FROM: Duke Power Company Charlotte, N. C. 28201 A. C. Thies			DATE OF DOC 12-31-73	DATE REC'D 1-9-74	LTR X	MEMO	RPT	OTHER
TO: A. Giambusso			ORIG 3 signed	CC	OTHER	SENT AEC PDR		X
						SENT LOCAL PDR		X
CLASS	UNCLASS XXXX	PROP INFO 1	INPUT X	NO CYS REC'D 40	DOCKET NO: <u>50-269/270</u>

ENCLOSURES:
Request for change to TECH SPEC for Oconee Units 1 & 2

Re: Oconee Nuclear Station
Units 1 and 2
Docket Nos. 50-269 and -270

Please find attached replacement pages for Oconee Technical Specification 3.5.2. It is requested that these changes, as indicated by vertical lines in the margins of the replacement pages, and the attached figures be approved and incorporated in the Oconee Technical Specifications.

CONTROL ROD GROUP WITHDRAWAL LIMITS FOR 4 PUMP OPERATION

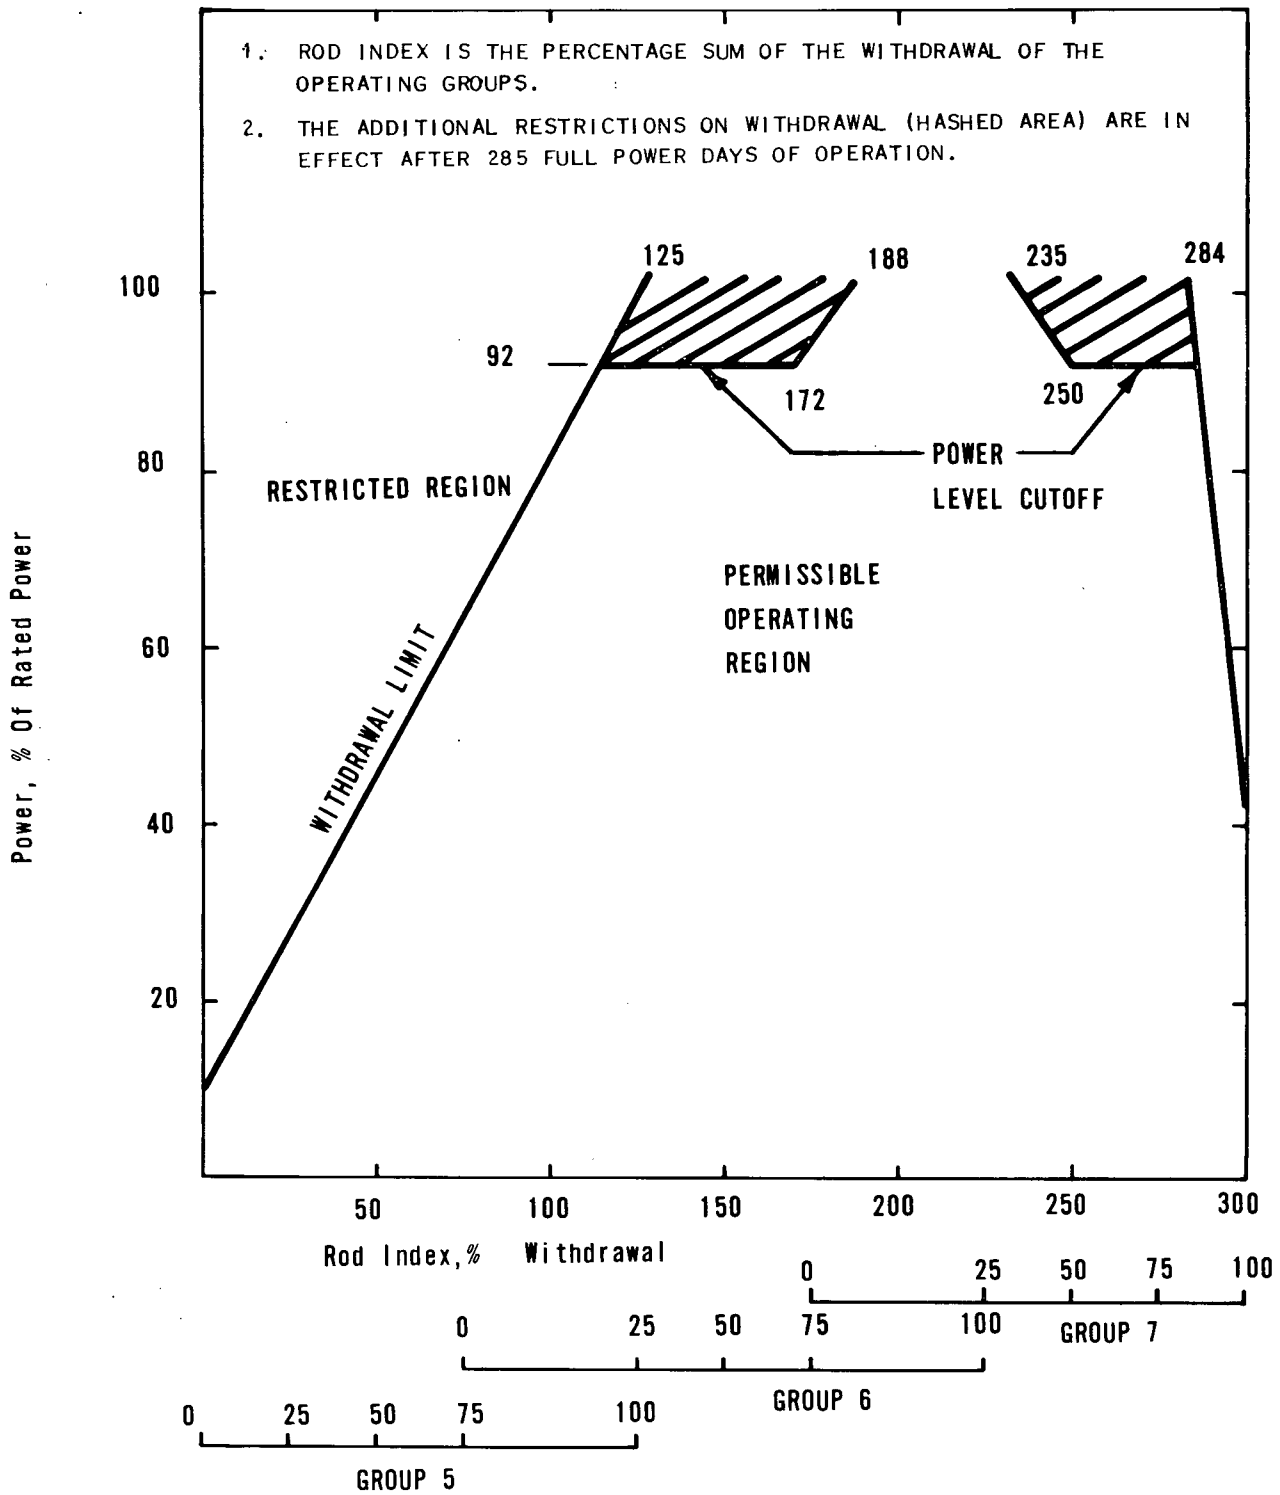
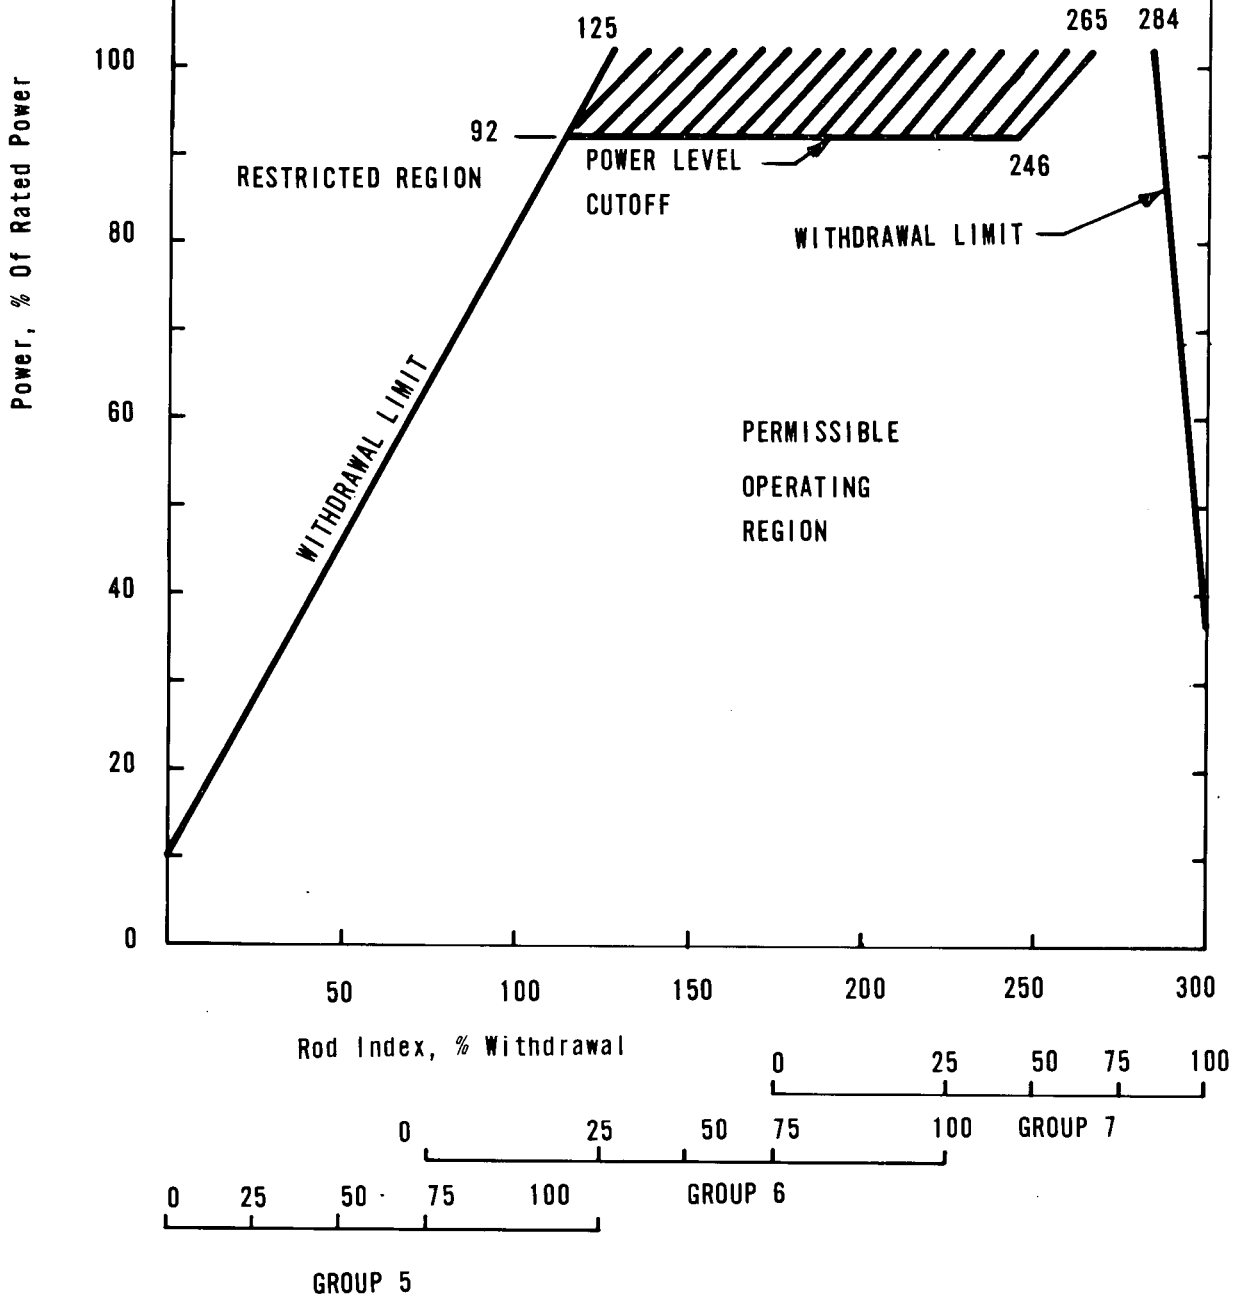
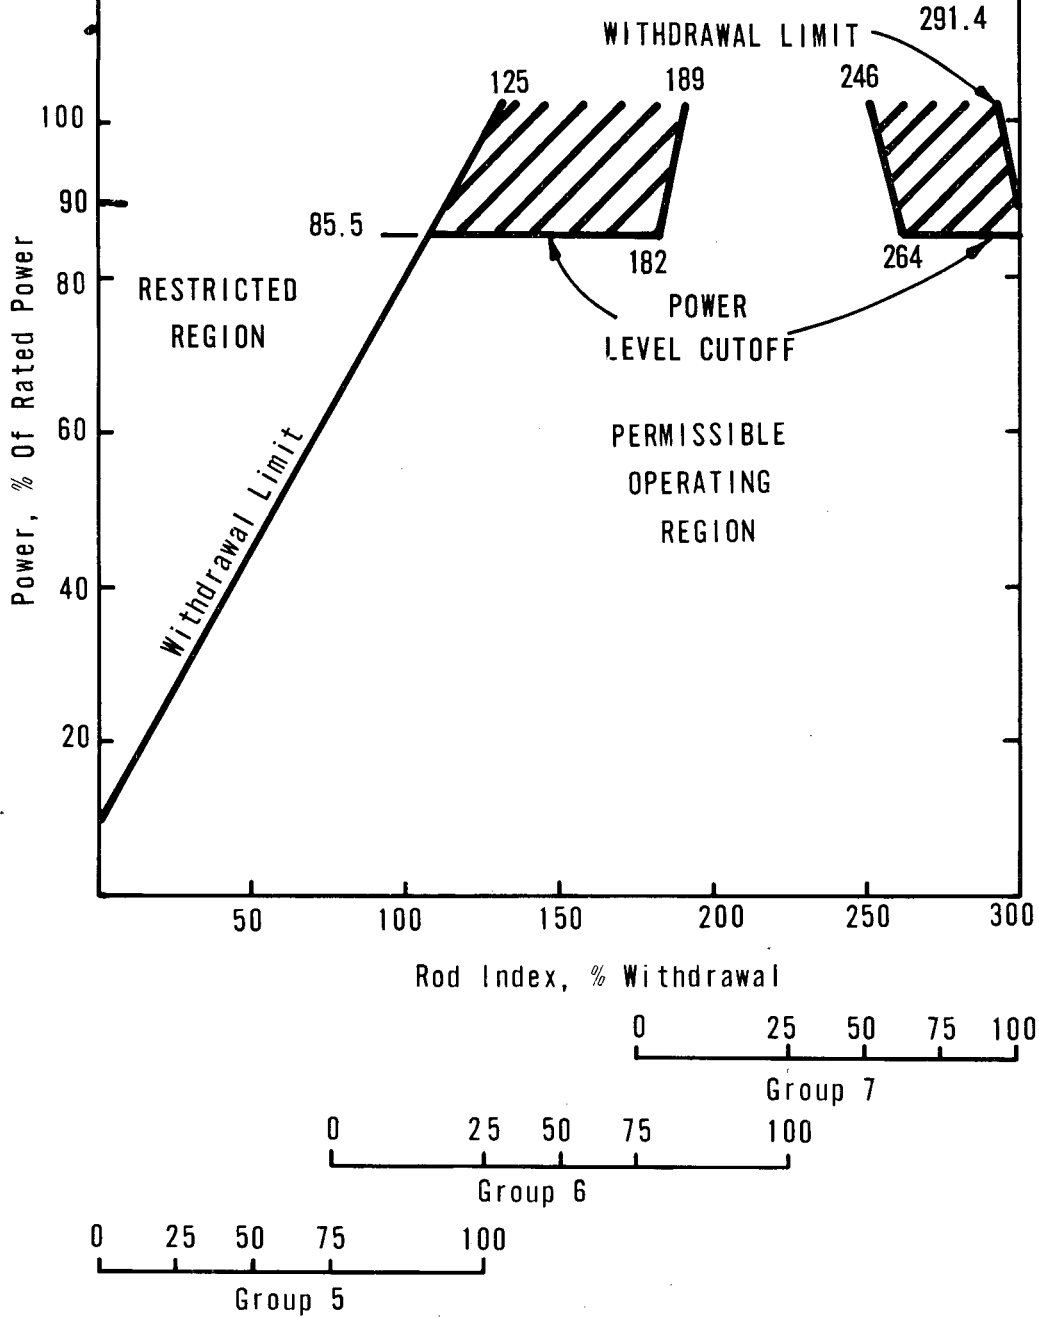
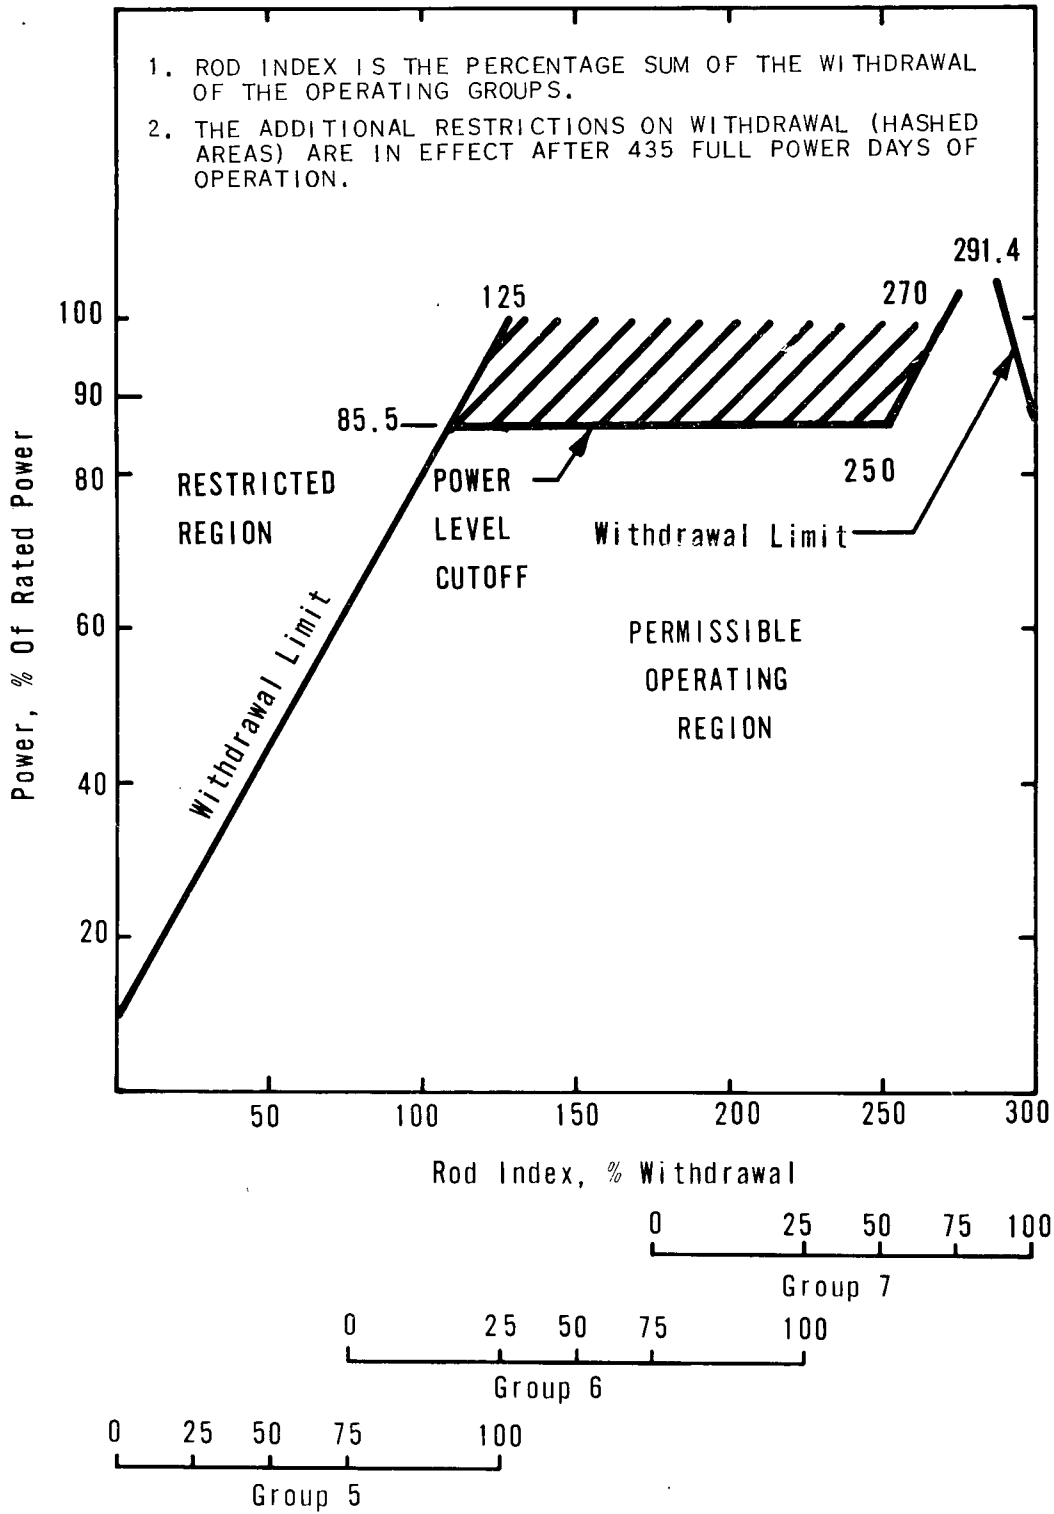
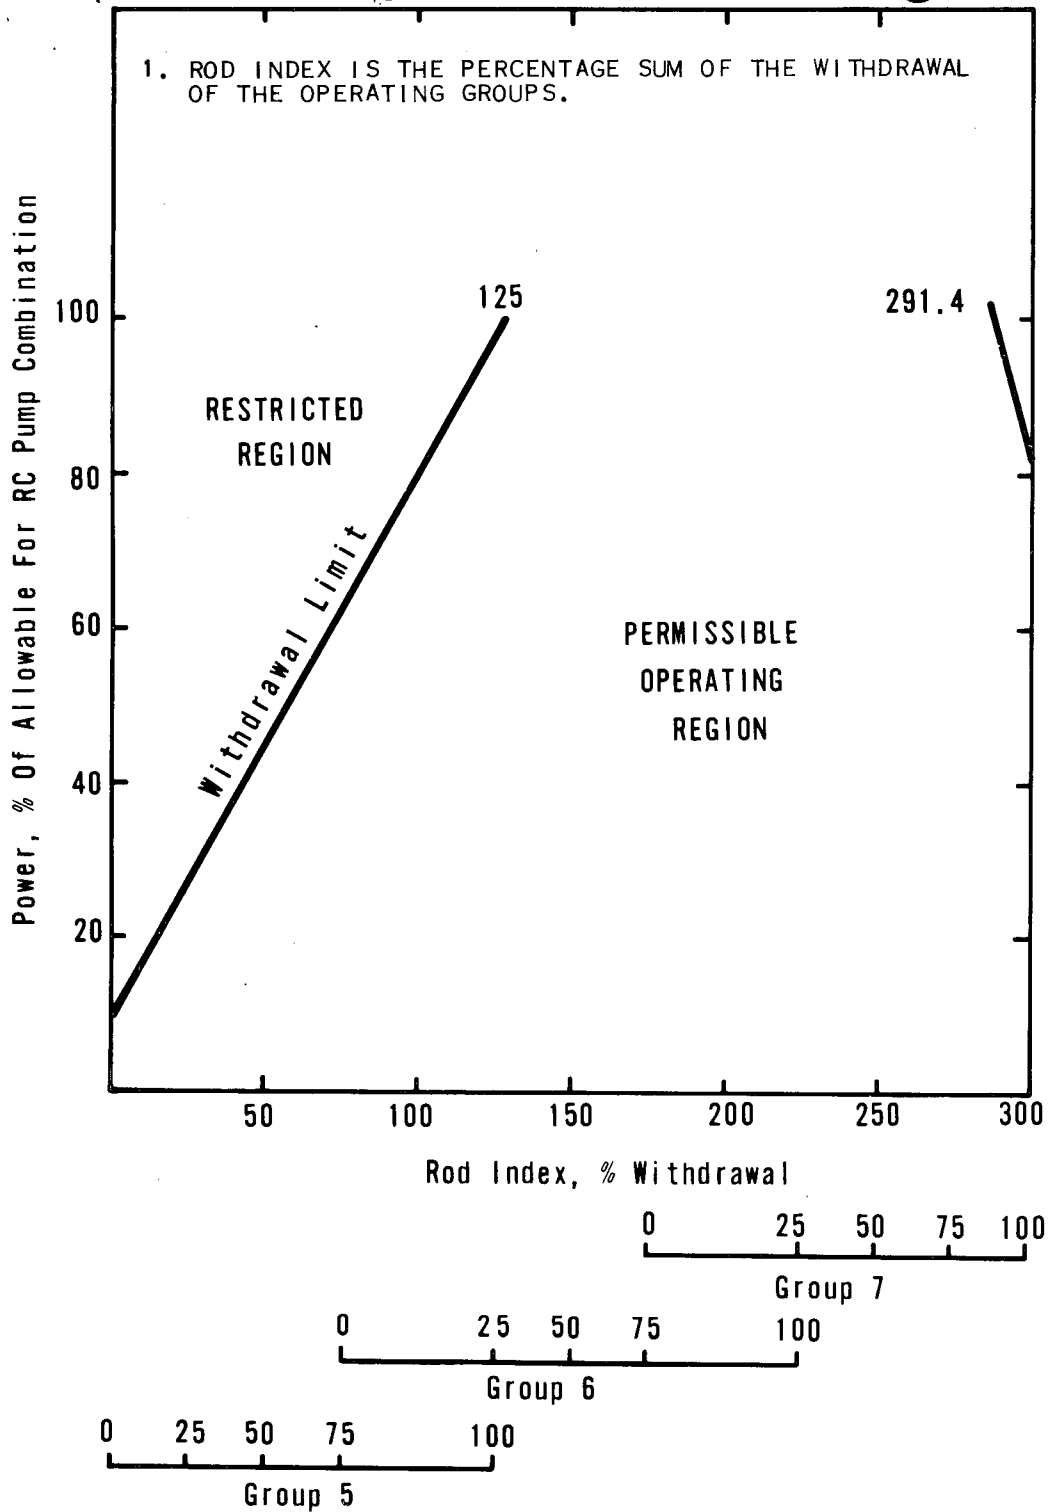
- 1. The protection system maximum allowable setpoints (Figure 2.3-2A-Unit 1; 2.3-2B-Unit 2) shall be reduced 2% in power for each 1% tilt.
 - 2. The control rod group withdrawal limits (Figures 3.5.2-1A1, 3.5.2-1A2, 3.5.2-2A Unit 1; 3.5.2-1B1, 3.5.2-1B2, 3.5.2-2B Unit 2) shall be reduced 2% in power for each 1% tilt in excess of 4%.

- c. Except for physics tests or exercising control rods, the control rod withdrawal limits are specified on Figures 3.5.2-1A1, 3.5.2-1B1, 3.5.2-1A2, and 3.5.2-1B2 for four pump operation and on Figure 3.5.2-2A and 3.5.2-2B for three or two pump operation. If the control rod position limits are exceeded, corrective measures shall be taken immediately to achieve an acceptable control rod position. Acceptable control rod positions shall be attained within four hours.
- d. Except for physics tests, power shall not be increased above the power level cutoff (see Figures 3.5.2-1) unless the xenon reactivity is within 10% of the equilibrium value for operation at rated power and asymptotically approaching stability.
